**CITY OF TEMPE
HISTORIC PRESERVATION COMMISSION**

Meeting Date: 05/11/2022
Agenda Item: 6

ACTION: Request for recommendation of approval of a General Plan Land Use Map Amendment from Public Open Space to Mixed-Use and a Density Map Amendment from No Density to High Density-Urban Core (more than 65 du/ac); a Zoning Map Amendment; a Planned Area Development Overlay to establish development standards; and a Development Plan Review for a new 14-story office building with ground floor commercial for 250 Rio, related to the proposed landscape improvements to the Ash Avenue Bridge abutment approach/roadbed and adjoining west side embankment, located at 250 West Rio Salado Parkway. The applicant is Gammage & Burnham P.L.C. (PL210130/HPO220003). The presenters are Manjula Vaz, Mike Duffy, and Mark Vinson. This item was previously considered at the April 2022 HPC meeting.

Excerpt from June 9, 2022, Historic Preservation Commission Meeting Minutes Pertaining to Potential Ash Avenue Bridge Abutment Approach Rehabilitation

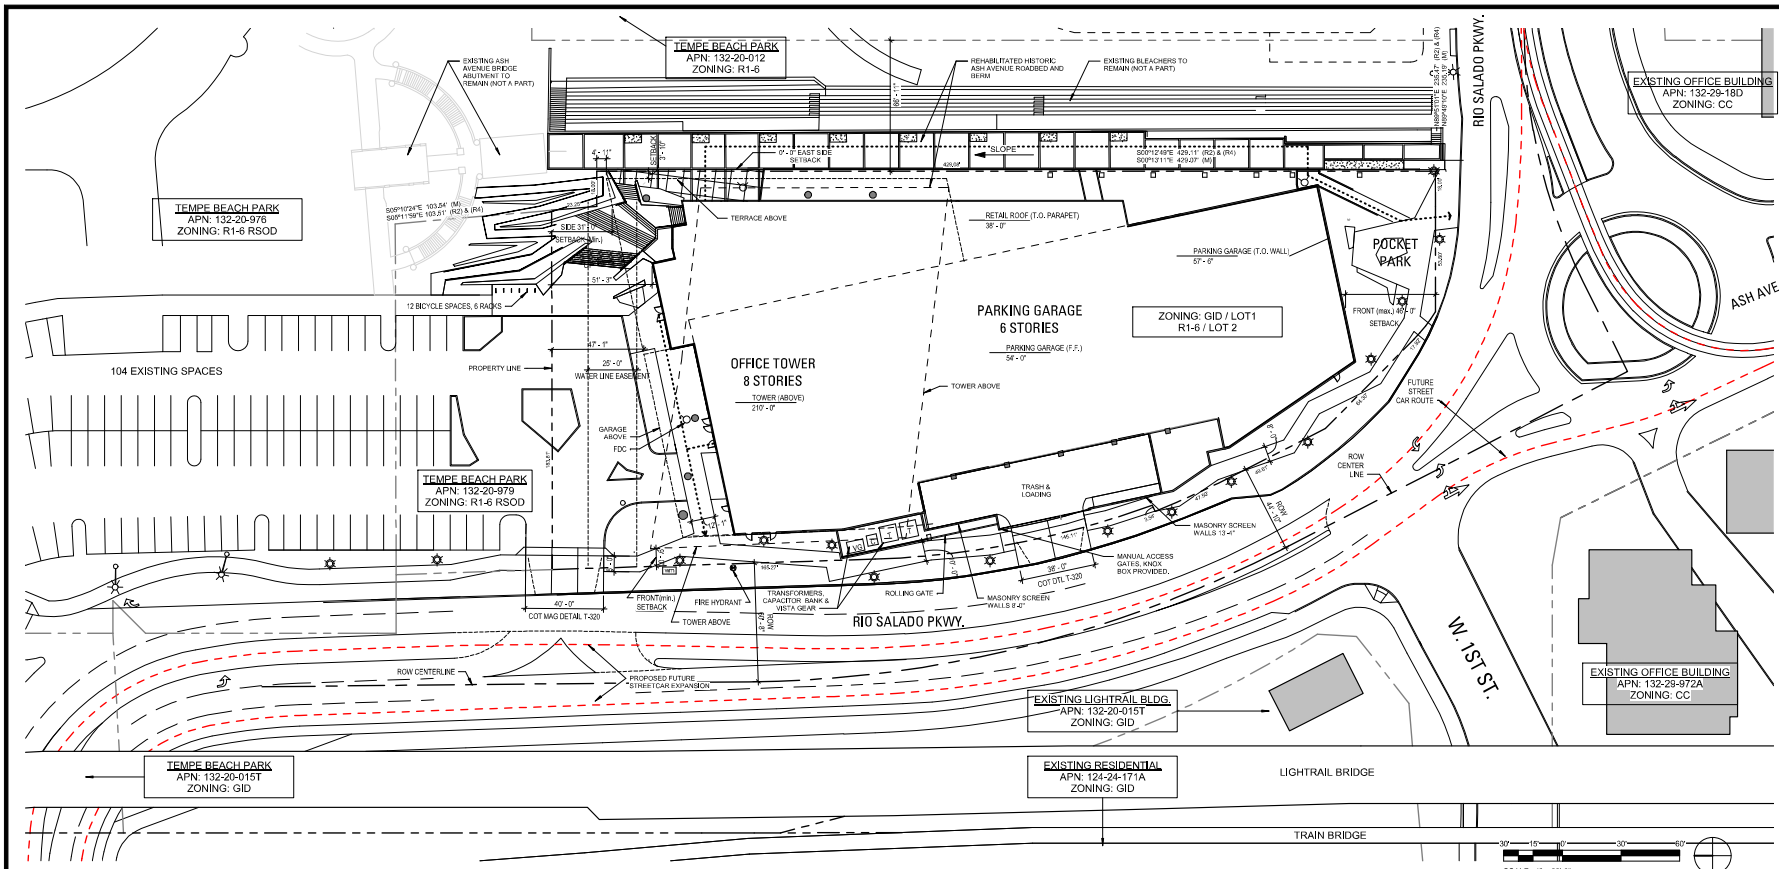
Chair [Chuck] Buss asked if the roadway in the drawing is off to the right and with the walkway will one be able to distinguish the older road.

Vice Chair [Martin] Ball stated that the critical thing in order to the roadbed is the section that is being maintained. While he does understand the Chair Buss concern about the loss of the historical elements that is something that could be explored more in the paving pattern and the exact amount of the original surface. The challenge will be maintaining the character and the publicness of the original historic element with the private structure. The shading of the area does not bring in cause for concern. In developing the design concept further there should be some type of distinction between the public and private areas. What are the purposed uses adjacent to the walkway?

Vice Chair Ball stated that there is a great opportunity to have an urban approach on the roundabout. Should consider exploring what potential there is to create a shaded urban character frontage along the roundabout side of the structure.

Mr. Duffy stated that it is a little difficult to read from the elevation that is shown to the commissioners because the burring is falling away from the landing. He showed the commissioners several elevations to help explain the drop off.

Commissioner Montero stated that she would like to see some photographs of the area and how it will tie into the plans next time they present to the Commission.

Mr. Duffy explained that the roadway is off to the right on the drawing and that there is new paving. They will have to be paved over to be rehabilitated for use. The elements of the historic road are in the cut out to reveal elements. That state that the road it is in is not readily available in place.

Mr. Duffy answered that one of the things central to the concept is the ideal that Ash Avenue is the Front door rather than Rio Salado. Being so close to the resources that will be addressed as the main focal point. There is a double height lobby that goes along with the site as Ash Avenue ramps up. The ground floor lobby is at a lower level and then the second-floor double height lobby enters at the North end of Ash Avenue.

drawing: Layout Plan

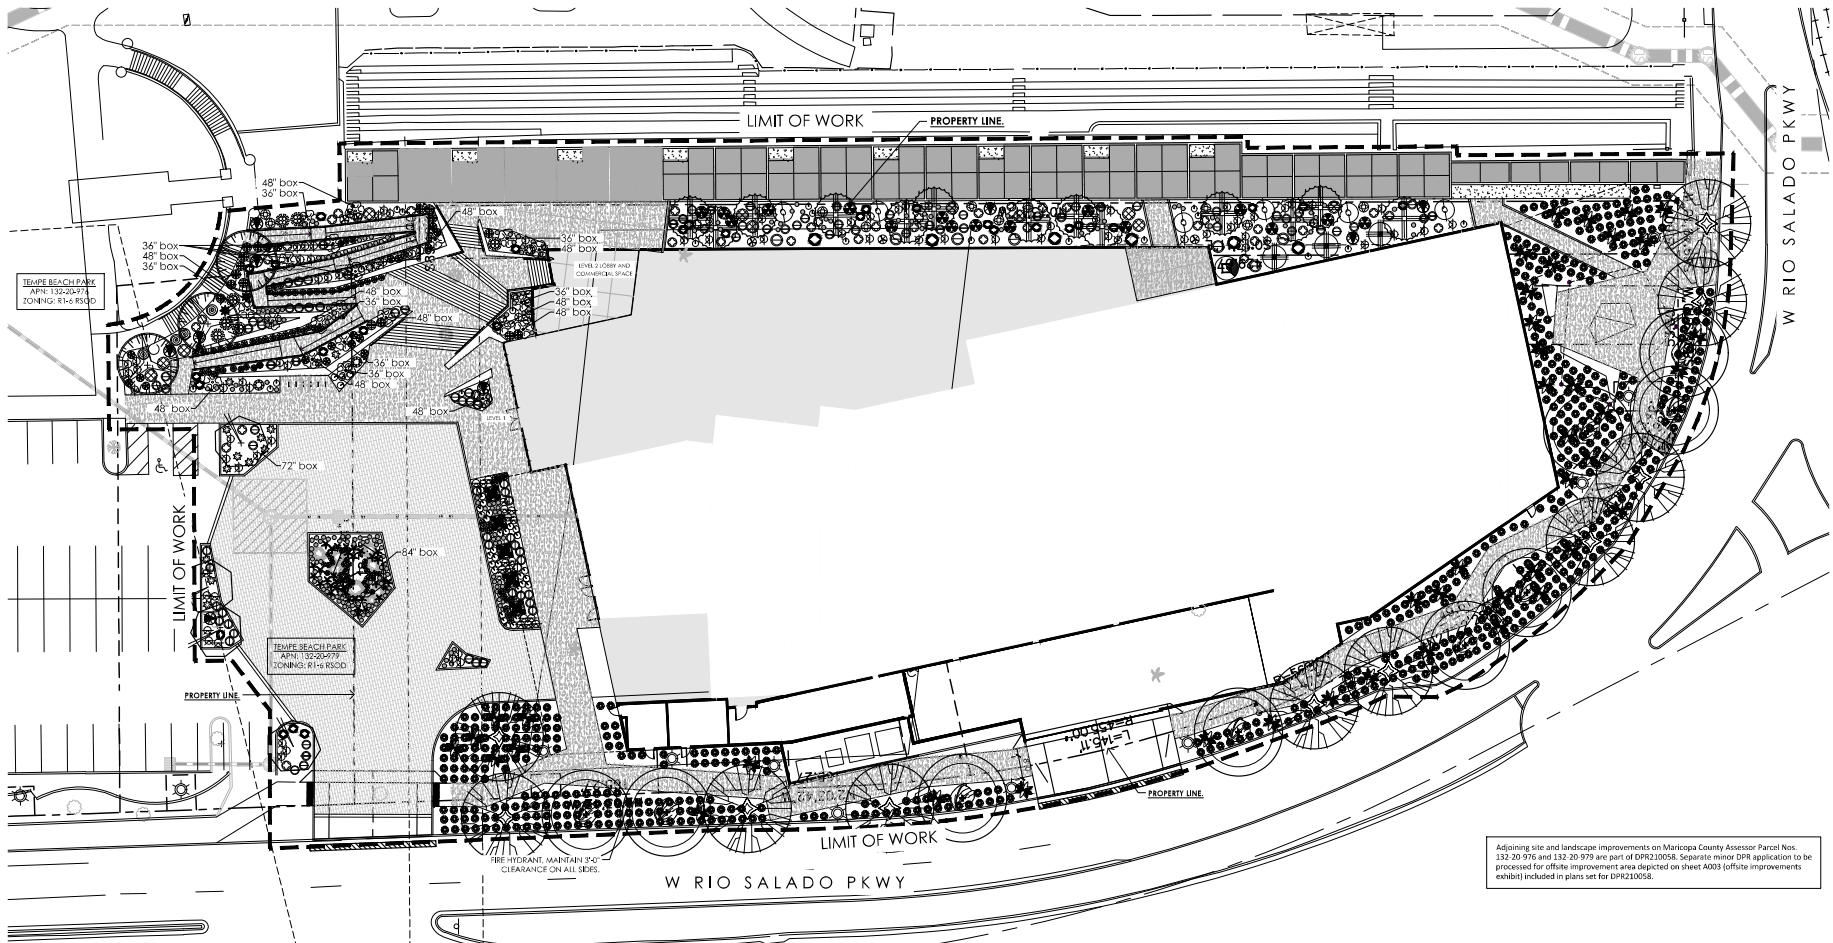
1. The applicant shall revisit the design to the Ash Avenue roadbed cut-outs to ensure safety and proper drainage and provide the revised landscape plan to the Historic Preservation Commission for review and comment.
2. The applicant shall continue to make the VinsonStudio PLLC's *Assessment of the Historic Roadbed and Bridge Abutment for the City of Tempe, Arizona* (2018) integral to their plan for restoring the Ash Avenue Bridge abutment approach.

4. Any minor changes to the landscape plan dated April 12, 2022, as submitted, shall be reviewed by the Historic Preservation Officer for compliance with the Certificate of Appropriateness (HPO220003) and issuance of a Certificate of No Effect.
